Greg Lewicki and Associates, PLLC

June 30, 2015

✓ **RE: Revenue Mine, Permit M-2012-032, Amendment AM-1
Adequacy Review #1 Response**

Map C-1: Baseline Conditions
Revenue Mine
Fortune Revenue Silver Mines, Inc.
M-2012-032 AM01
Adequacy Review #1 Response

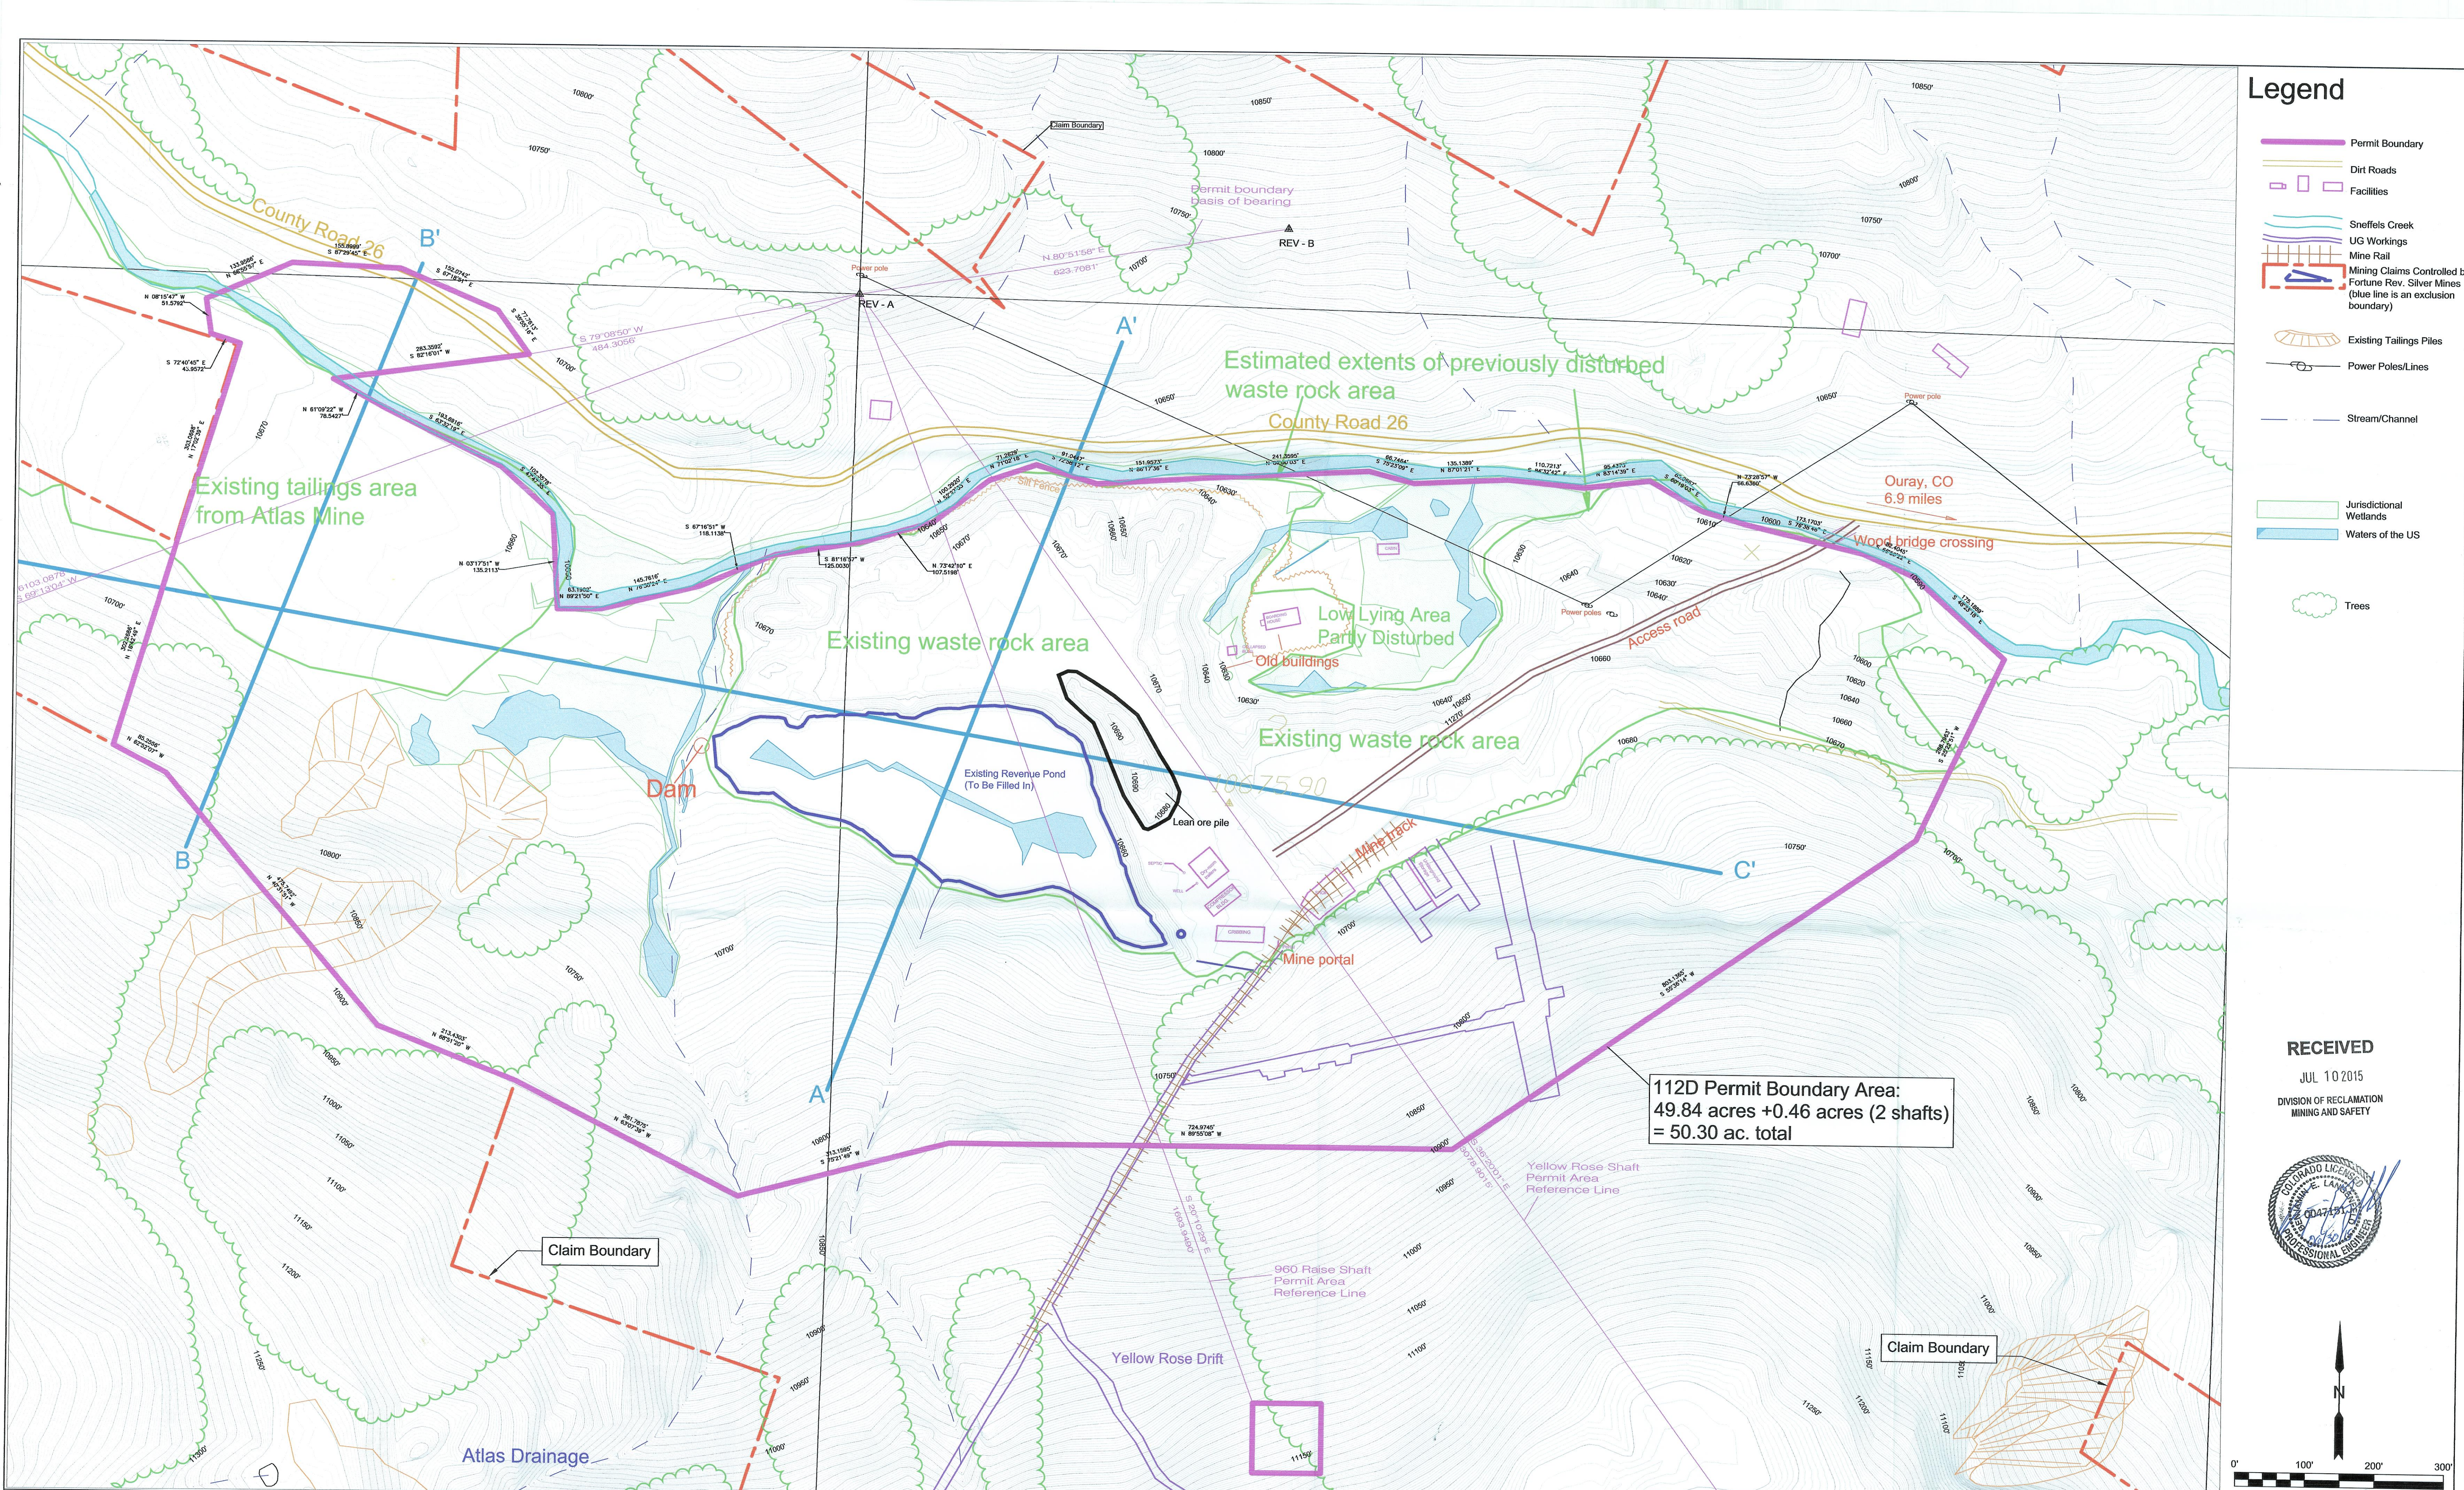
- 1. The series of mine plan maps does not fully include depiction of a couple features that are important and which should be added to the maps. On the set of maps for the Revenue Mine complex (Map C-1 through C-4), the lacking features specifically are: the underground decline leading from the mill level down to the crushing gallery; and the surface pipe(s) that convey portal discharge water to the mine pond. Please ensure that the upland diversion ditches are shown in their correct locations.**

Map C-1 represents the pre-mine conditions for the site, and therefore does not contain any of the structures built as part of mining operations. Map C-11 has been created to show all of the facilities and mill details in greater scale and clarity. Other maps have been clarified as needed to address this adequacy item.
